# INFILL INCENTIVE DISTRICT DESIGN PACKAGE for 1 WEST BROADWAY

**REVISED: 18 SEPTEMBER 2015**

# 4 DEVELOPMENT PLAN PACKAGE SUBMITTAL

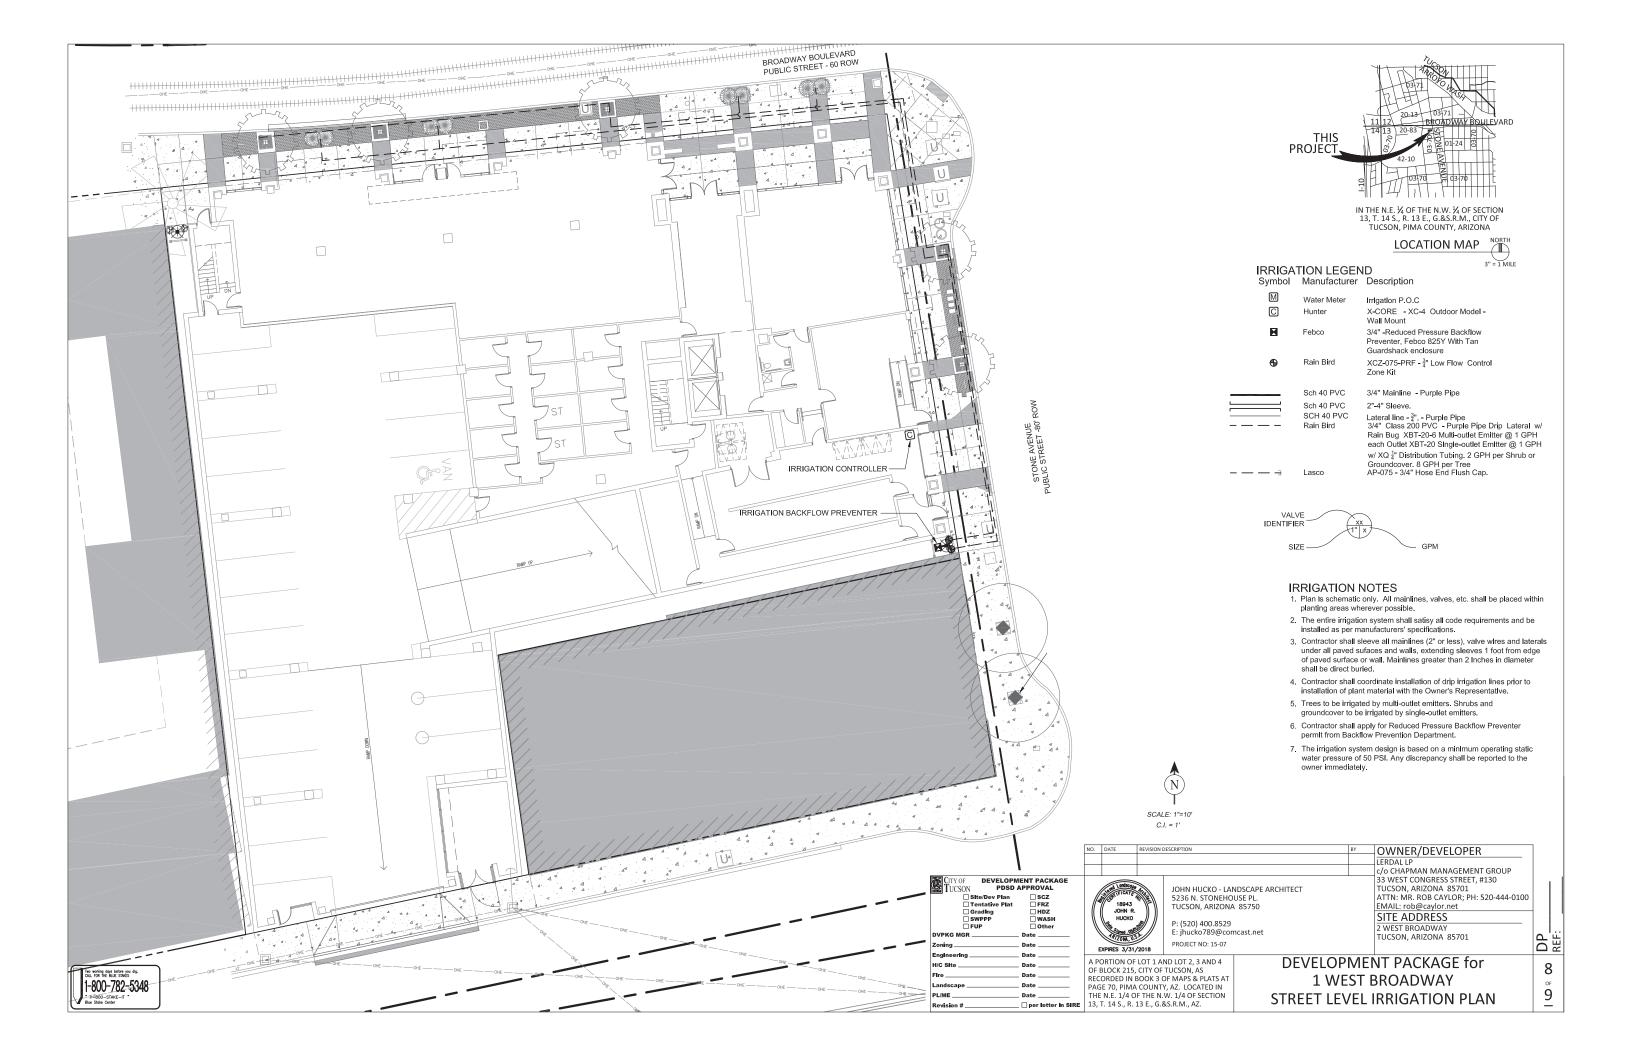
- 8) AM Sec.2-06.4.8.F: Revise the development plan package to label all existing storm drainage facilities on and adjacent to the site with the Improvement Plan Number in plan view. Clarify the existing storm drain inlets shown on Sheet 4, per the landscape plans these are to act as tree wells.

TYPICAL PARKING DETAIL SCALE: 1"=10' 2ND FLOOR ADA

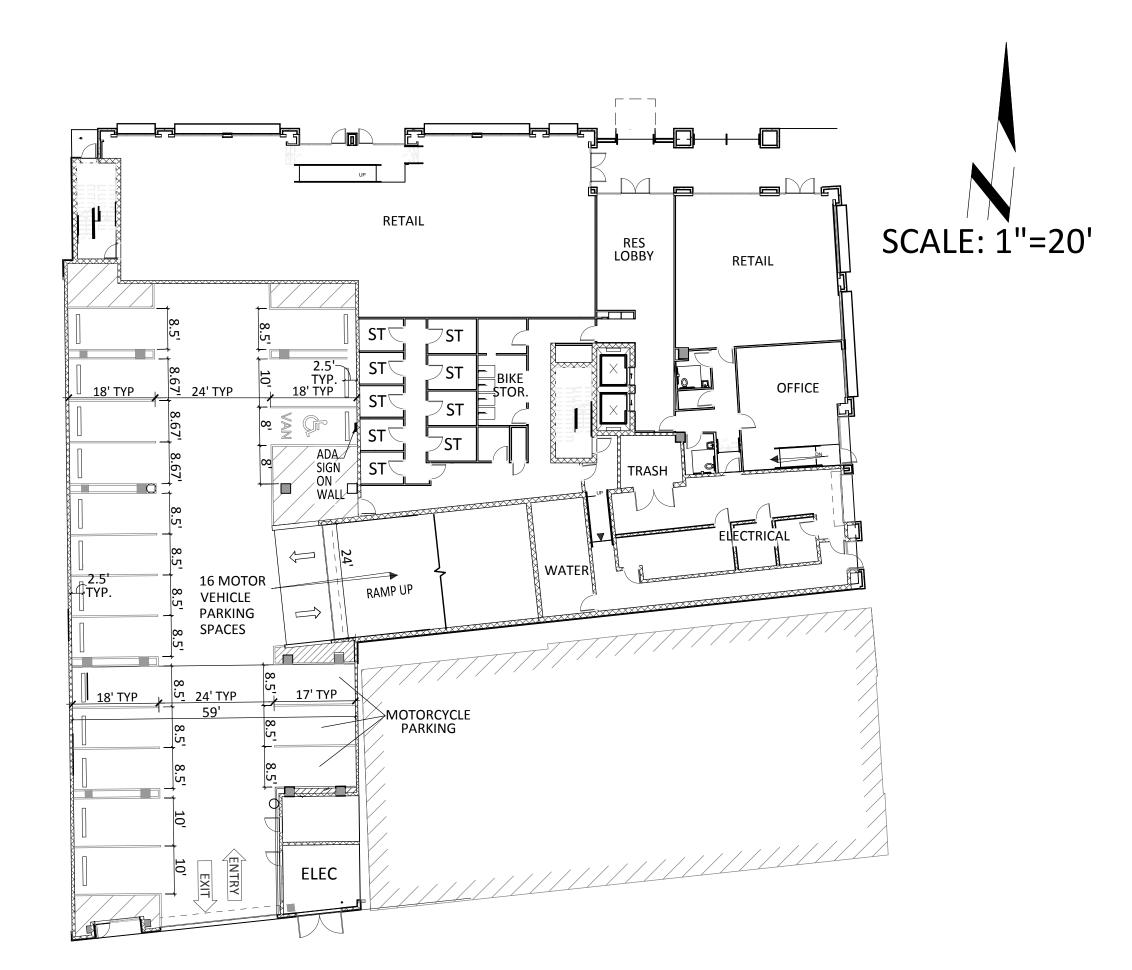
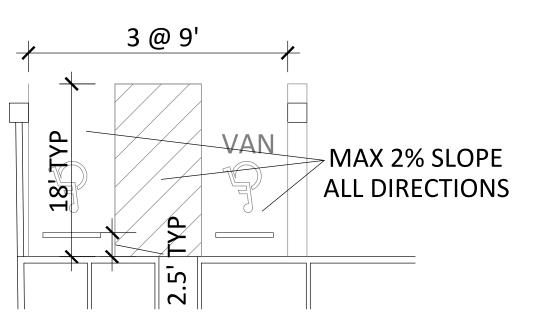
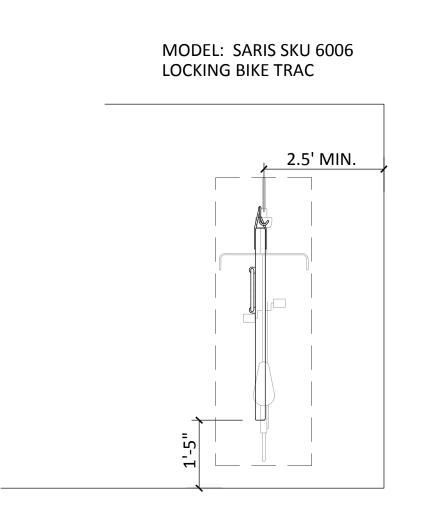
- 11) AM Sec.2-06.4.9.H.5.a Revise the development plan package to provide a standard vehicle parking space detail. Verify on the detail the required 2.5 foot overhang for spaces adjacent to sidewalks, landscape areas, wall, proposed riprap swale, etc. Refer to UDC Figure 7.4.6-C for the 2.5 foot overhang dimension.
